SP Transmission & Distribution

Regulation of Independent Electricity Distribution Network Operators- Initial Proposals Document.

I am writing on behalf of SP Transmission & Distribution in response to the 'Regulation of Independent Electricity Distribution Network Operators- Initial Proposals Document' (January 2005). We are pleased to have the opportunity to comment on these proposals.

Typical proposed arrangement for LV CT metering.

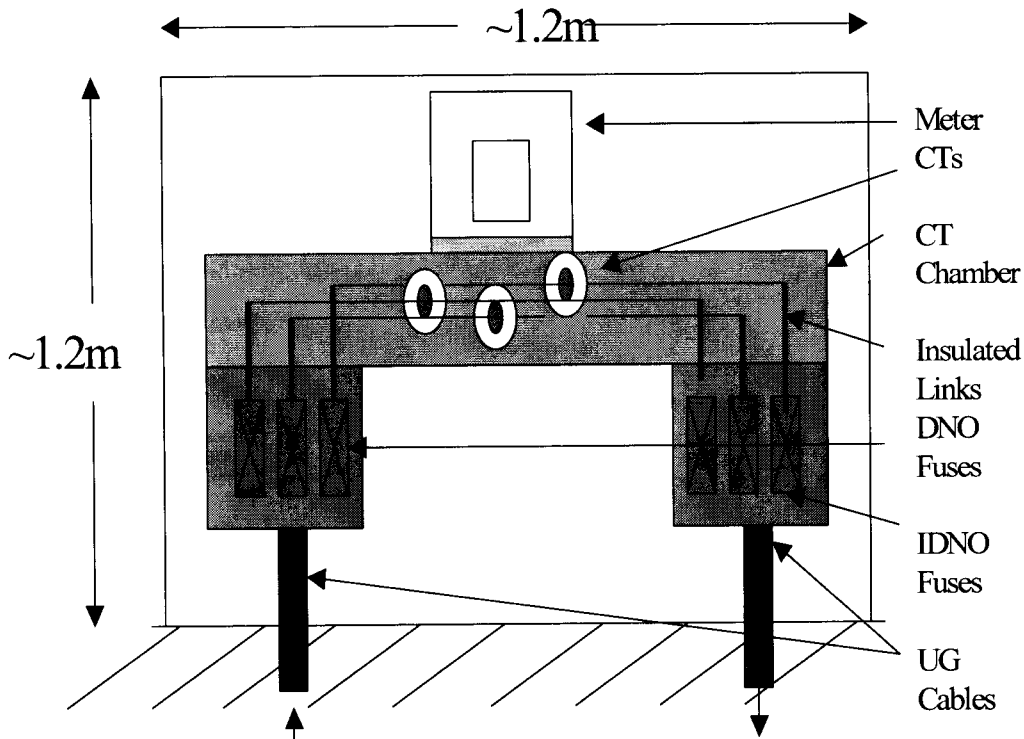
As other important boundary equipment, such as DNO cut-out fuses and the IDNO's own protective devices or a means of isolation, require an enclosure in any case, a modern solid state meter should be very easily accommodated within the enclosure.

A 3 phase, 100-amp electricity meter should be no more than 250mm(h) x 200mm(w) x 100mm (d). The size of enclosure or pillar for LV boundary equipment is likely to be no larger than most street furniture required by BT, Public Lighting or DNOs ~1.2m(h)

For developments of more than 30 houses but less than 150 houses, where a DNO should be able to provide a connection from the LV network without establishing a network substation, the space for the termination equipment and the meter is more of an issue. However, we believe that an enclosure no taller than current electrical street furniture, of 1.2m x 1.2m would accommodate the equipment.

The arrangement of the fuses, metering panel and independent network isolation would be as shown below:
